Application No. R-39626

Crowe Reservoir No. 1 and storage of 6.0 a.f. of water from an unnamed stream (South Yamhill River)(Willamette River) for irrigation.

Proof of Appropriation of Water

FINAL PROOF SURVEY

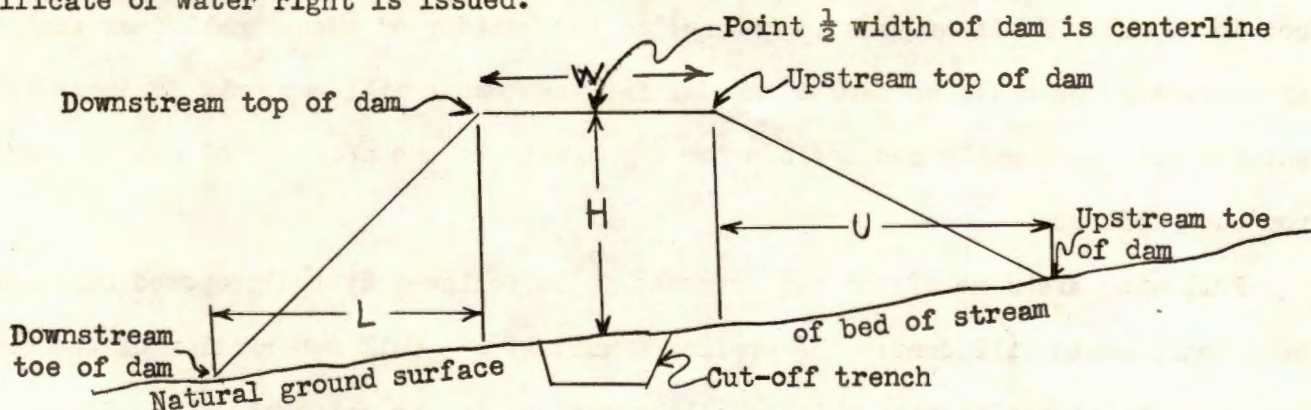
During examination of the reservoir application, it is noted that, according to the data in this office, the peak flood of fifty-year frequency which might be expected in the drainage basin described in your application could contribute as much as 45 cubic feet of water per second to the flow of the stream at the point where your dam is to be constructed. The spillway you have described for your reservoir would not provide sufficient freeboard if such a flood occurred. It is suggested that you amend your application by increasing the depth of the spillway from 2 feet to 2.5 feet. Your application may be amended without being returned to you if you will give us your written authorization.

Here is a copy of our plan
where the pond is to be built
the spill way will be lowered
to 2.5 feet instead of 2 feet.

Earth Dam:

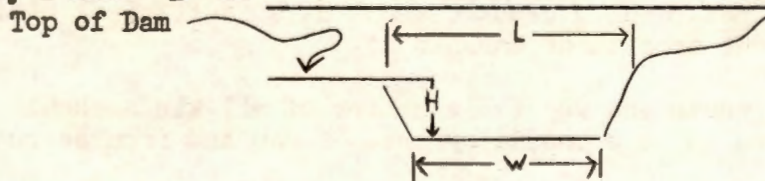
3/13/64 - for, M^2 $Q = 49 \text{ cfs}$ - use 45 cfs.

$b = 8$
 $Z = 1$
 $d_{\text{max}} = 2$

$Q = \frac{49}{8} = 6.1$
 $Z_b = \frac{1}{8} = .12$

$d_c = 1$

$V_c = \frac{49}{10} = 4.9$
 $A_c = 1(8 + 2 \times 1) = 10 \text{ ft}^2$

$\frac{V_c^3}{2g} = .37$

$H_p = 1 + 1.4 \times \frac{.37}{2} = 1.52$

$0.2 > 1.3$

Suggest spill depth of 2.5 ft will be 8' as slope 1:1
